## Correction to the F3N Optional Manoeuvre B.1 in the 2013 Edition of the Sporting Code

F3N Optional Manoeuvre B.1 should read:

B.1 Two opposite pirofunnels K 10

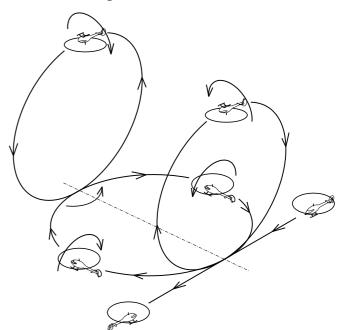
B.1 Two opposite pirofunnels. K-factor

= 10

MA enters in inverted flight and performs a quarter pirouette. When it crosses the centreline it enters a funnel with the tail pointing to the circle centre and starts pirouetting in a way, that after each quarter circle the fuselage has changed its direction about 180° (model starts nose to the judges, after a quarter circle the tail points to the judges, after a half circle the nose again, after 3 quarters the tail and after the circle the nose again). After one funnel the pirouetting direction is changed and a second funnel follows with the same conditions for the pirouette. After the second funnel MA exits the manoeuvre with a quarter pirouette to inverted flight.
